Flash Memory Products
1999 Data Book Amendment, Revision 10

The changes and corrections in this amendment apply to the 1999 AMD Flash Memory Products Data Book, publication number 11796F. Updates to this amendment will be available only through AMD's web site, at http://www.amd.com/products/nvd/techdocs/tech-

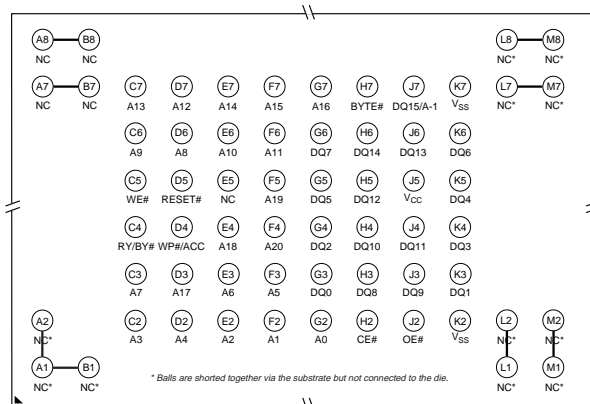
Page 3-98: The FBGA drawing has been modified to show how the outrigger balls are shorted:

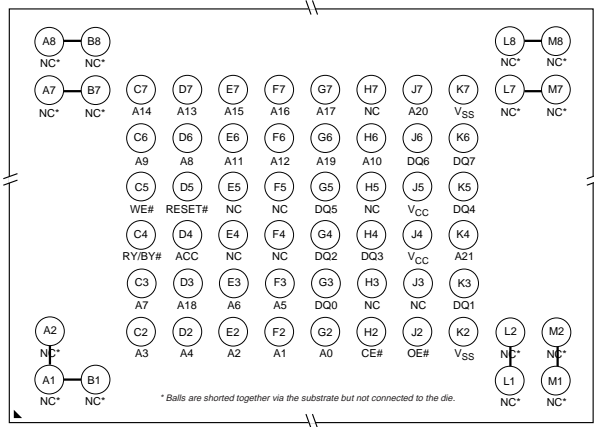
Page 5-340. The updated drawing shows how the out-rigger balls are shorted:

TS 048: 48-Pin Standard Pinout TSOP

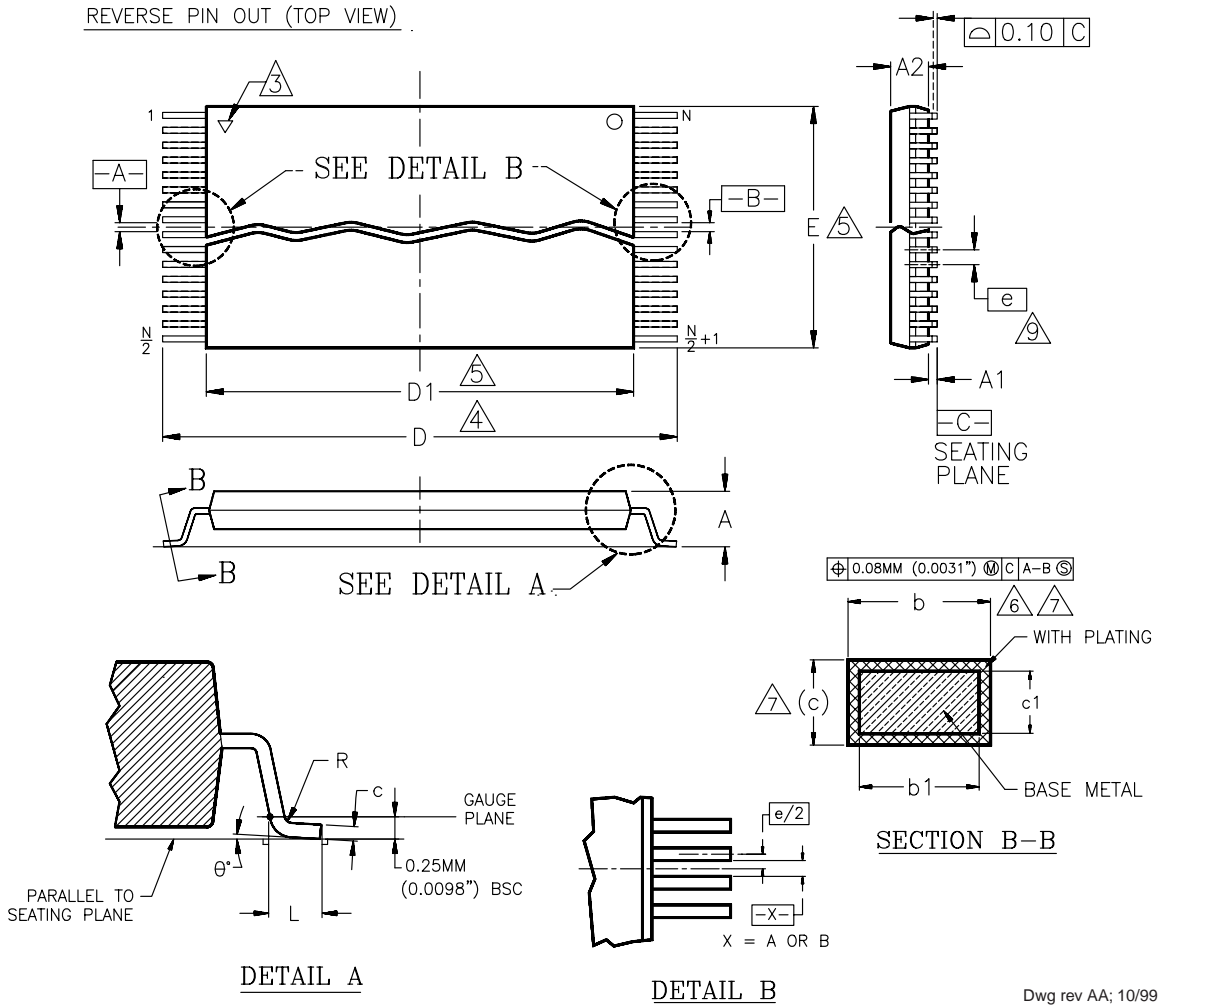
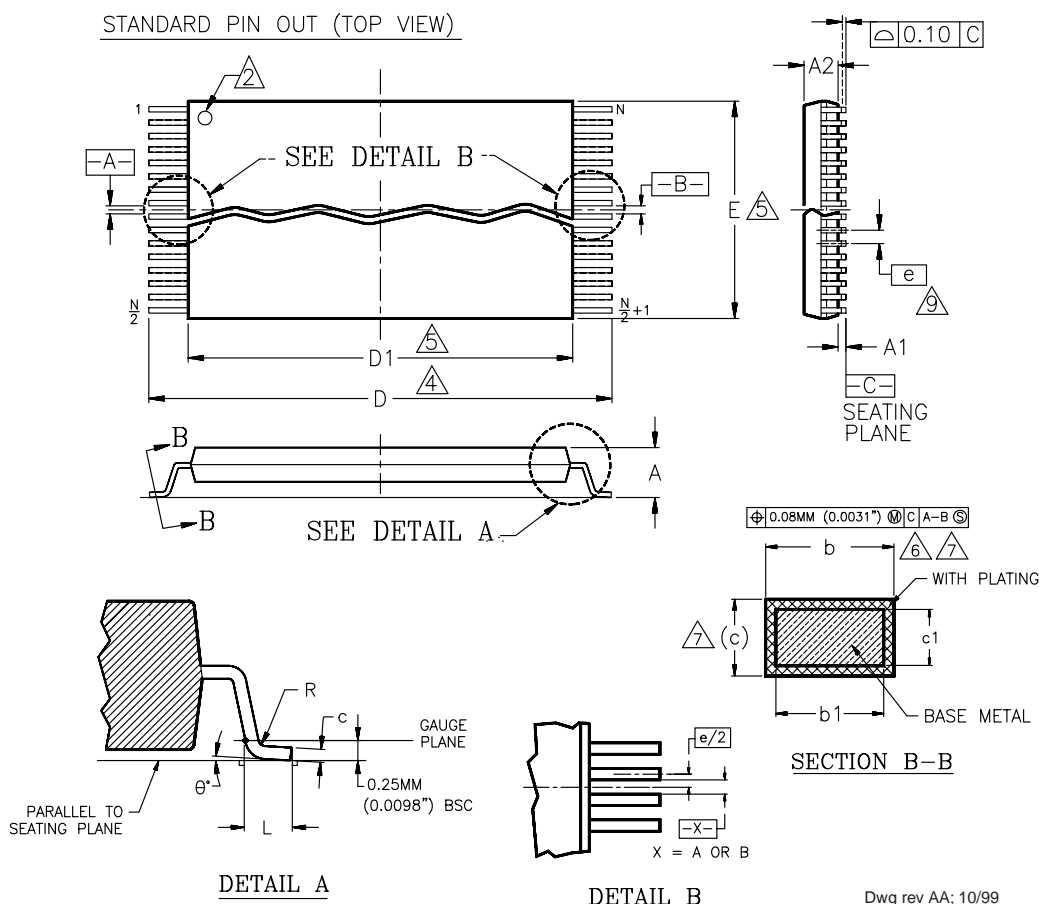
Page 38 of the online full data sheet, *TS 048:* The drawing previously showed the TSR 048 package; now shows the proper package.

FBA048: 48-Ball 6 x 8 mm FBGA

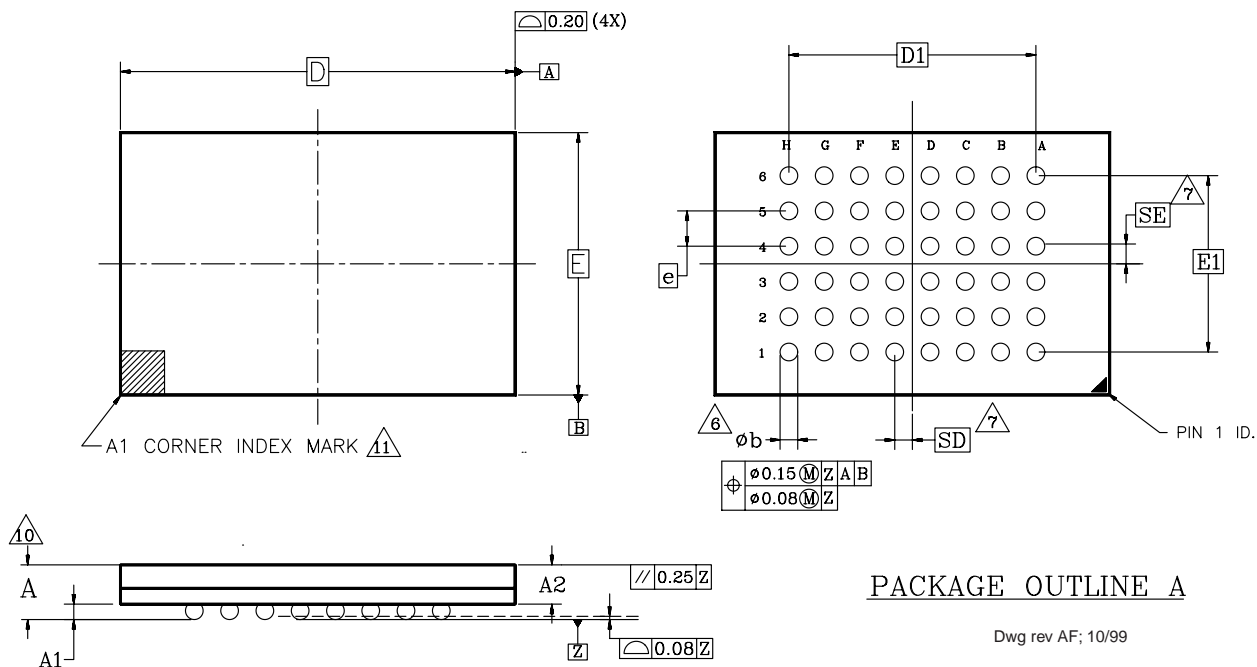
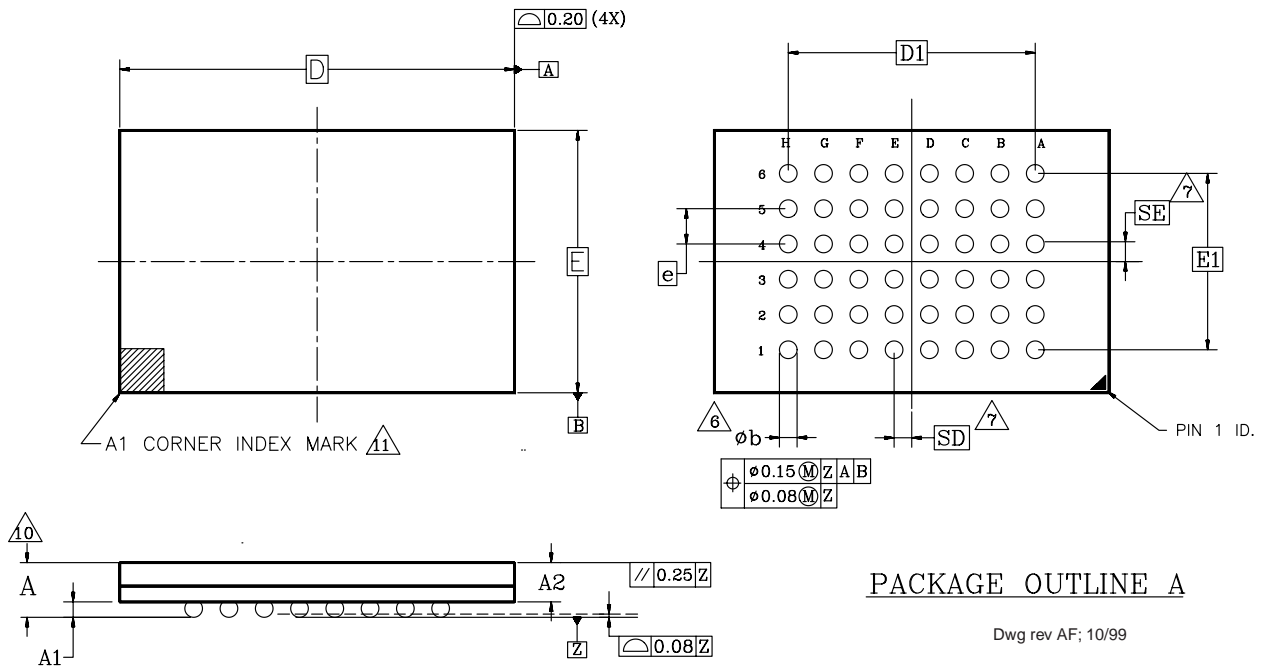
Page 10-13: The FGA048 package has been replaced by the FBA048. The FBA048 package is currenlty offered only on the Am29LV400B.

FBB048: 48-Ball 6 x 9 mm FBGA

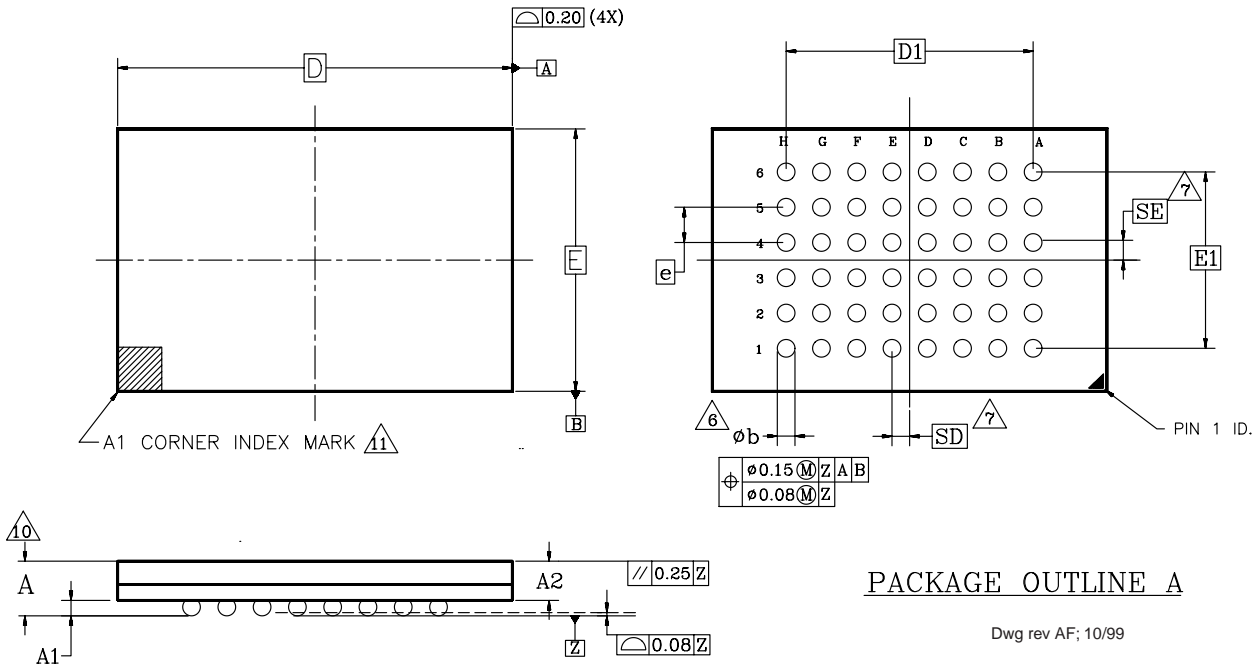
Page 10-14: The corrected drawing for the FBB048 package is shown on page 25 of this amendment.

(Amendment +1 corrects the online data sheet. The FBB048 drawing was replaced with the one shown on page 25 of this document.)

FBD063: 63-Ball 8 x 14 mm FBGA

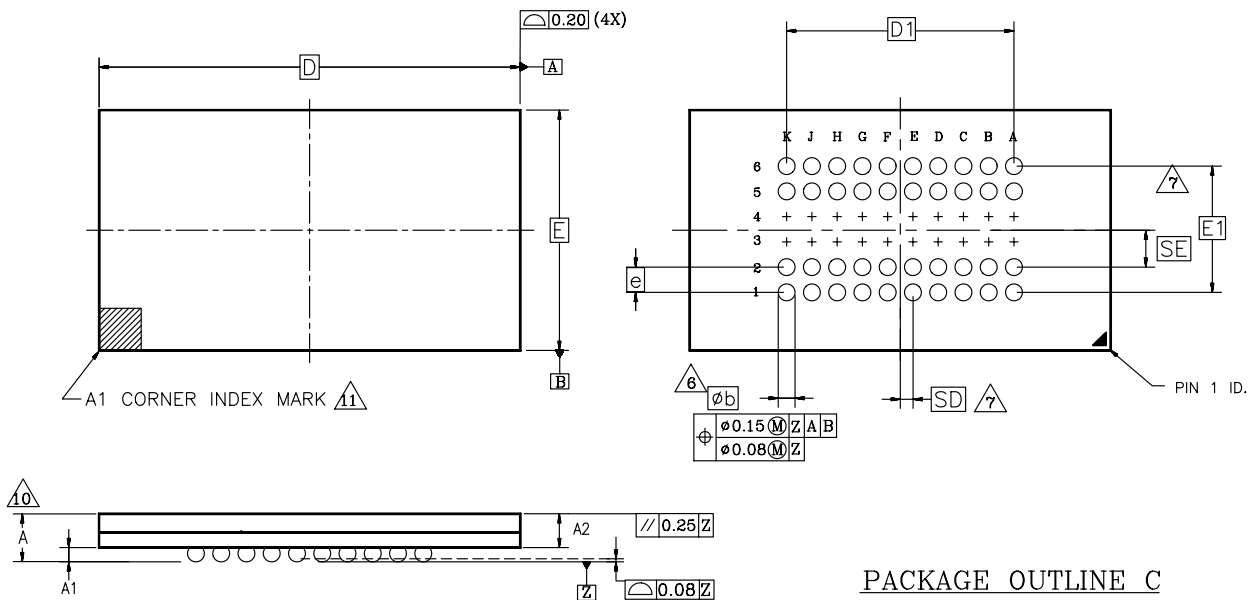
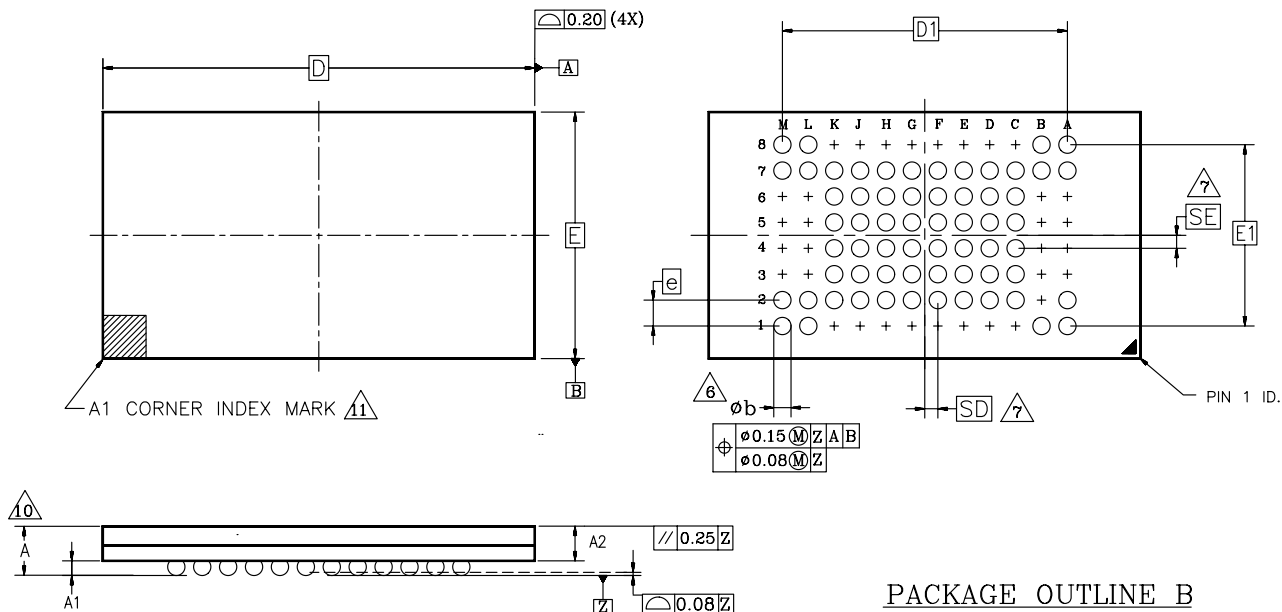
Page 10-16: The dimensions of the FBGA package should be stated as 8 x 14 mm.
